## S6 and S9 AUDIO MODIFICATION

Prepared by: EDC Inc.

January 24, 2008

Figure 1: Solder Side of Radio

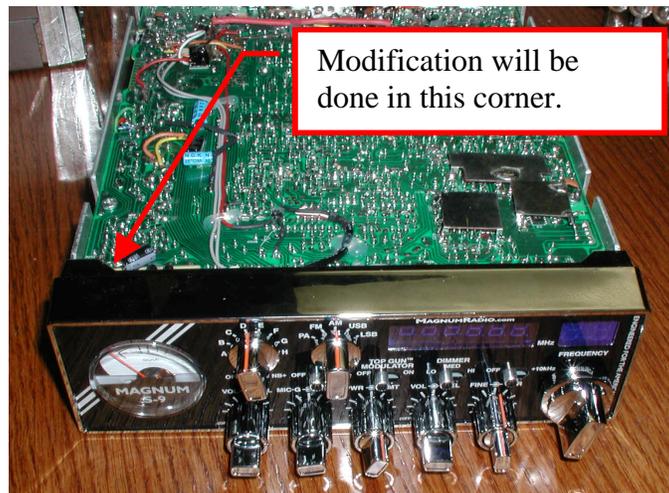
With the top cover removed and the solder side facing up, see Figure 1.

Figure 2: Installing the 220uF Capacitor

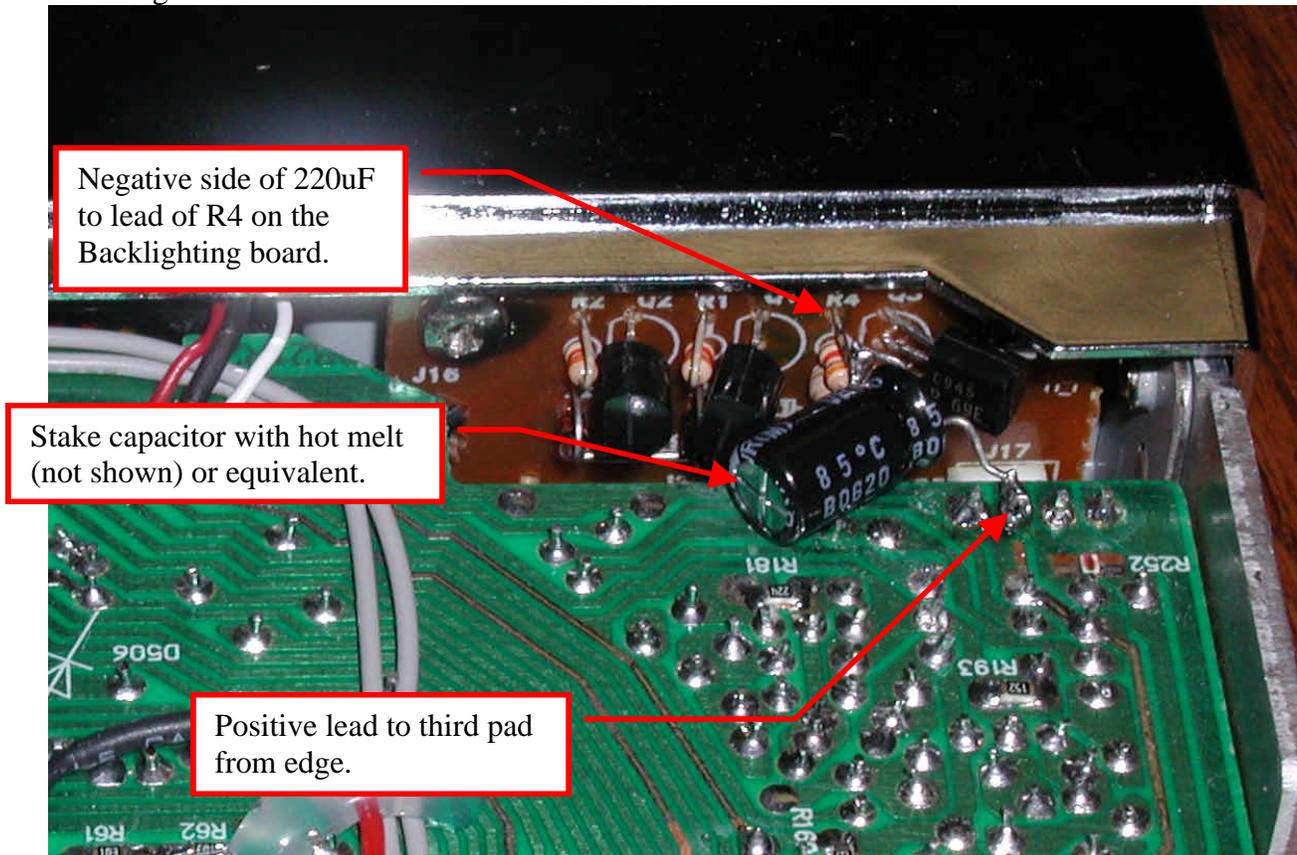
Add 220uF 16V capacitor positive side to third pin from edge and negative side to lead of R4 on Backlight board. See Figure 2.
